**Re: Technical Response (Updated) to Sydney Metro RFI – 105 Miller Street,
North Sydney (Noise and Vibration Impact Assessment)**

105 MILLER STREET - COMMERCIAL SCHEME

NOISE AND VIBRATION IMPACT ASSESSMENT

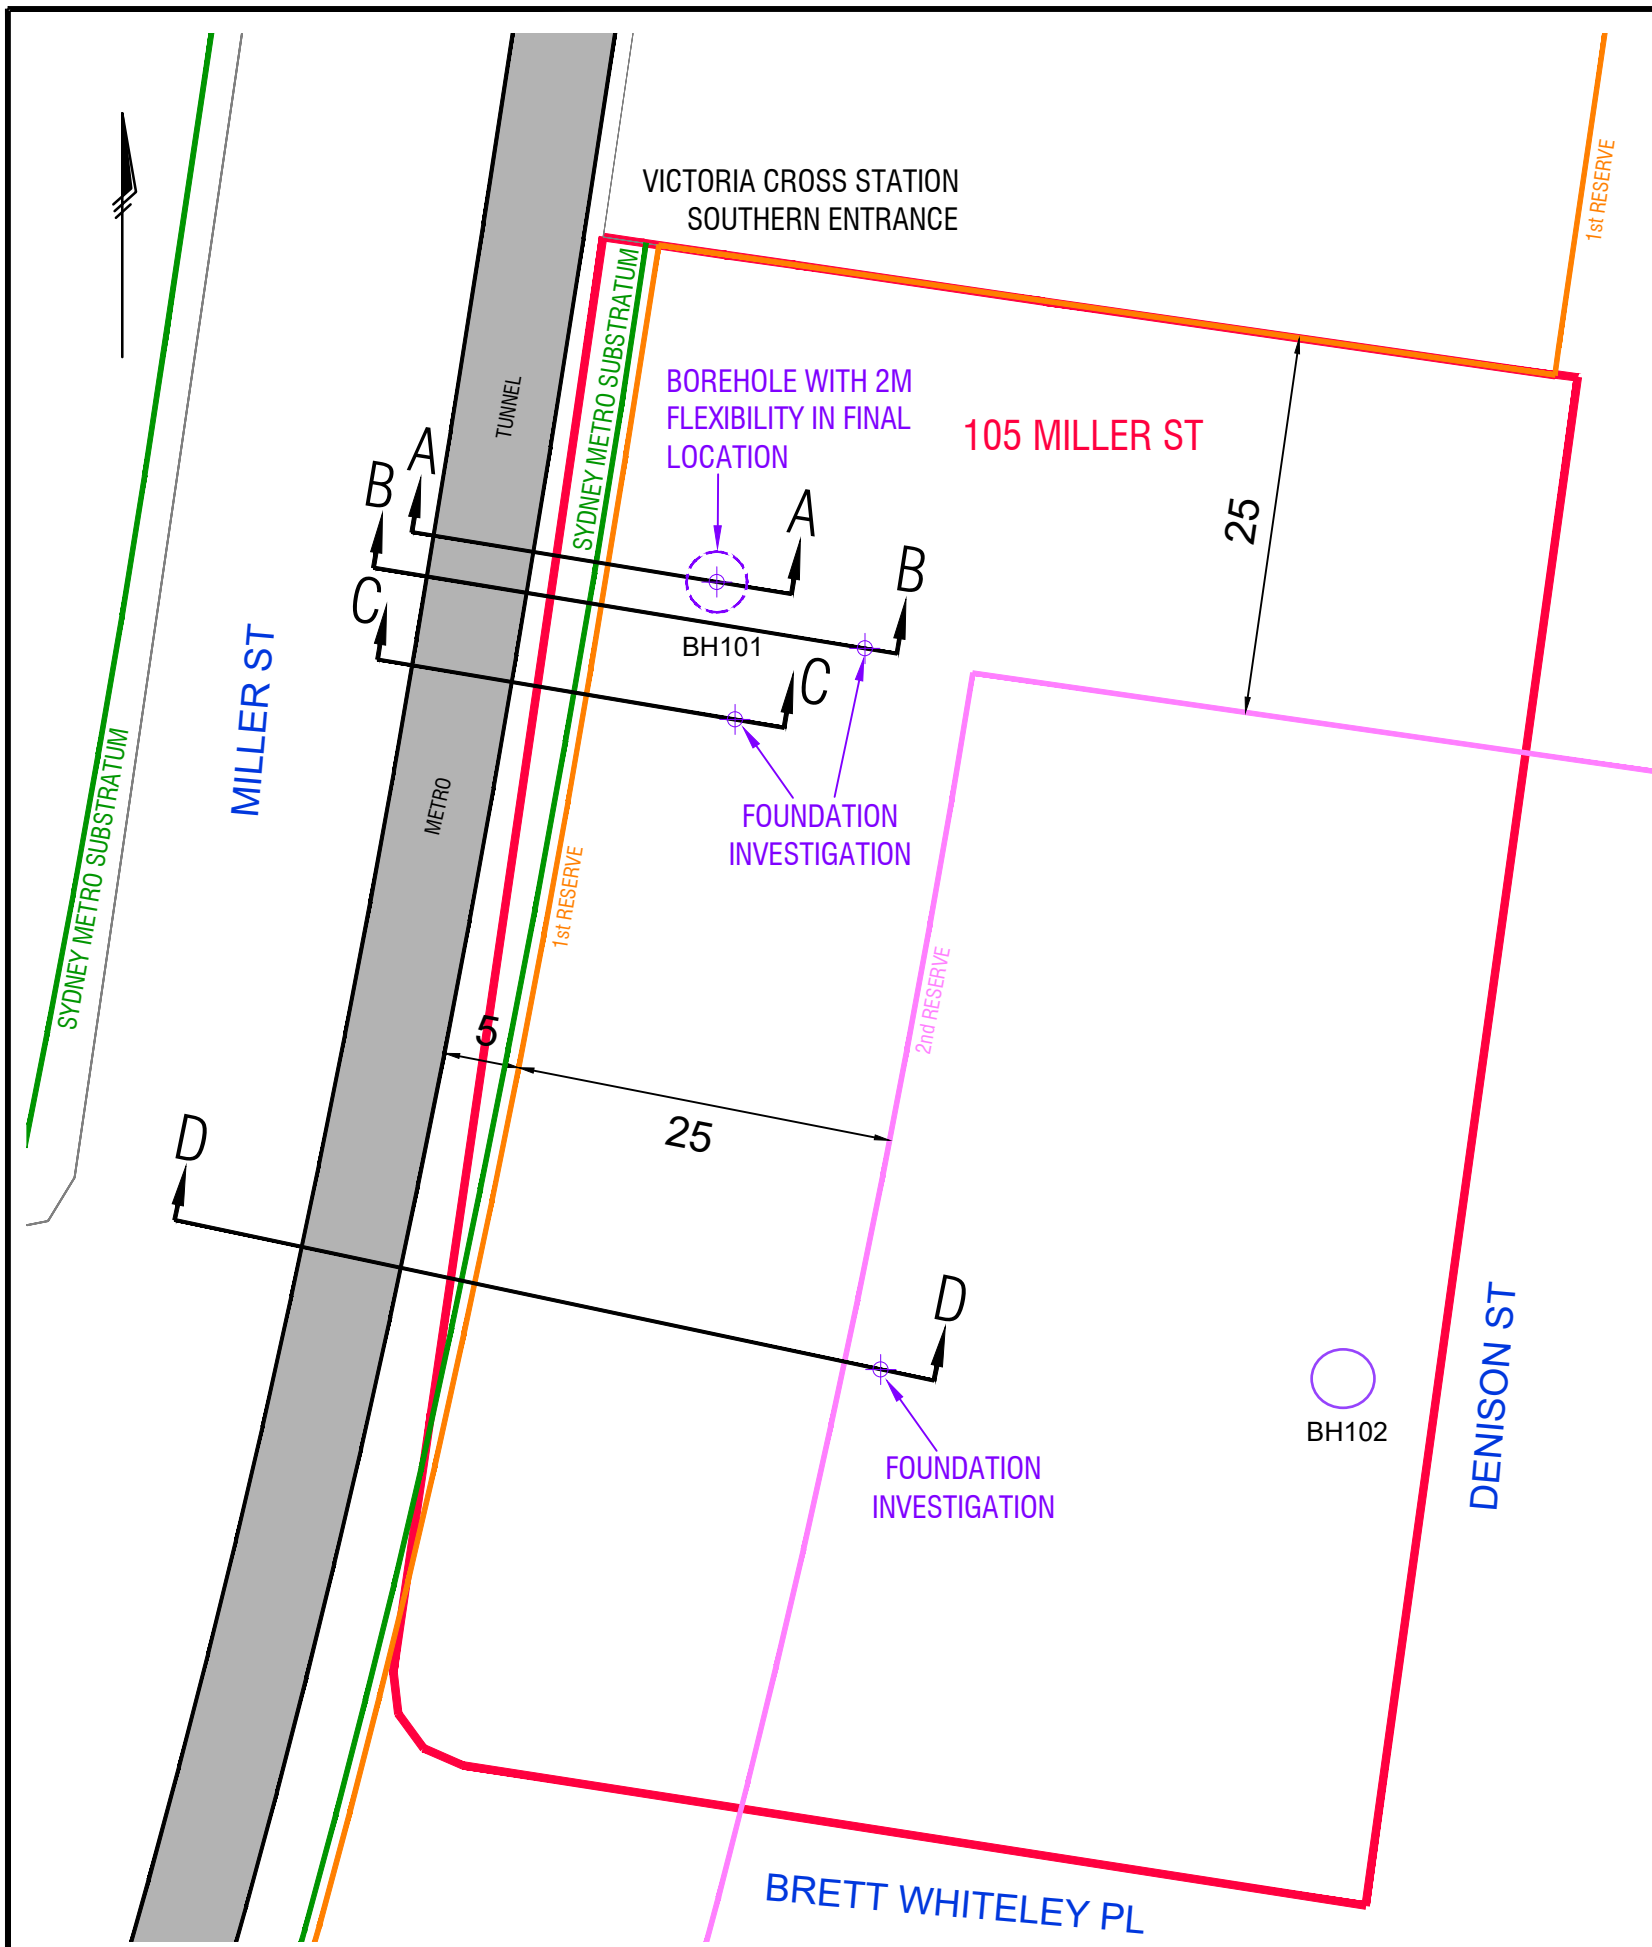
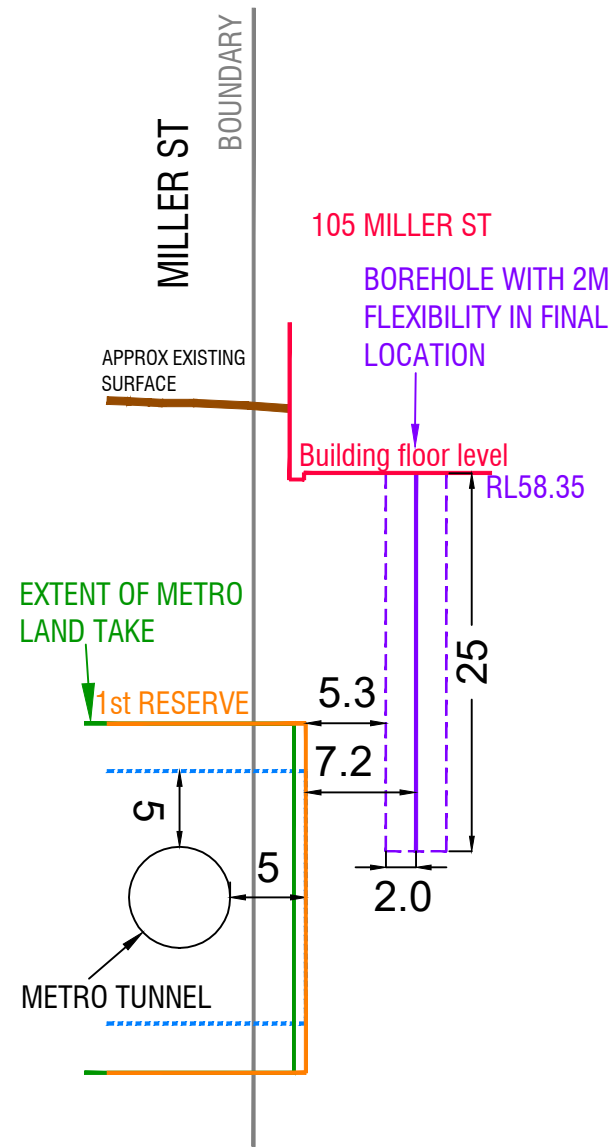
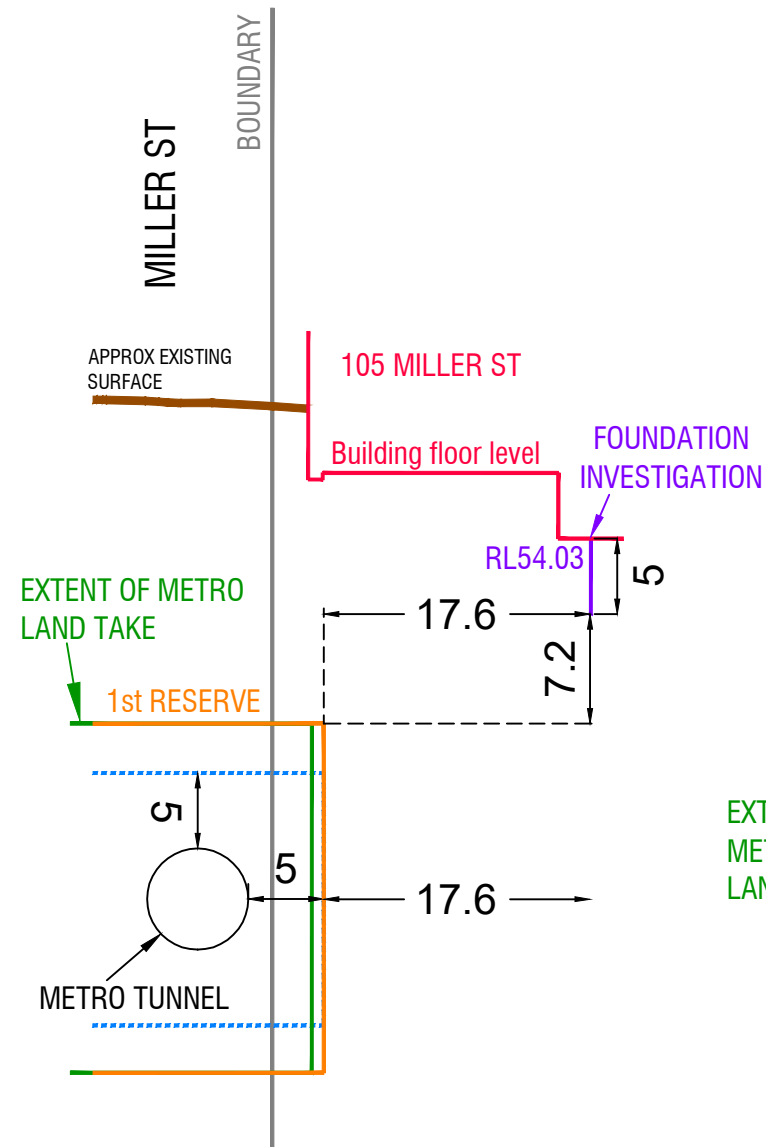
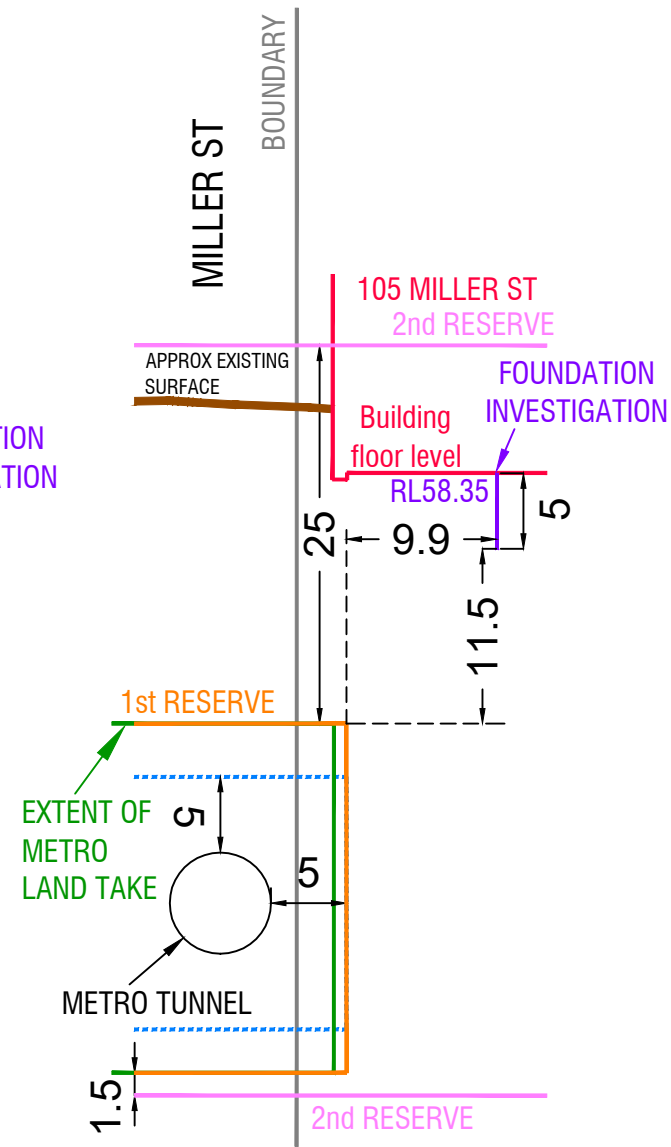
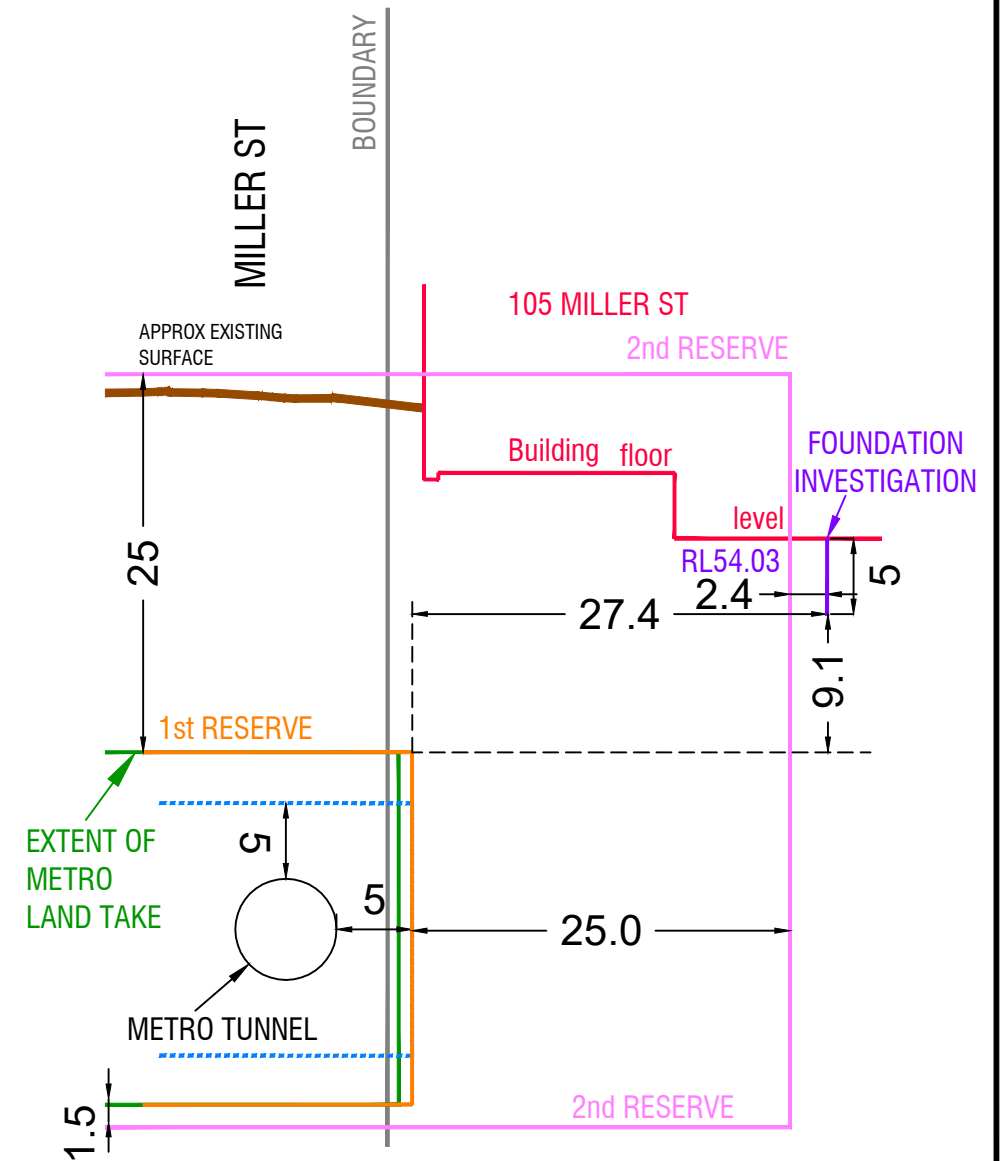
A review of the structural and geotechnical design confirms that a portion of the development footprint sits within the Second Reserve, as shown in the RPS survey (Attachment B). Key considerations include:

- Excavation Depths: No excavations exceed 2m in depth within the Second Reserve, except for a single sewer pit to 2.4m, which poses no risk to Metro assets.
- Foundations and Structure:
 - The existing primary structural elements within the Second Reserve are retained where possible.
 - The new core structure and deep footings are located outside the Reserve.
 - No piling is proposed.
- Proximity to Metro Infrastructure: The closest new column footings are located at least 20m from the ISD boundary.
- Construction Methodology: The proposed approach aligns with the Sydney Metro Underground Corridor Protection Technical Guidelines, ensuring structural isolation, limited vibration transfer, and minimal excavation near sensitive areas.

These design outcomes ensure that the development will not interfere with Metro infrastructure through vibration, settlement, or direct loading.

- Attachment B – RPS survey showing the boundary of the First and Second Reserves
- Attachment C – Architectural section showing the proximity of development works to the Metro tunnel and ISD
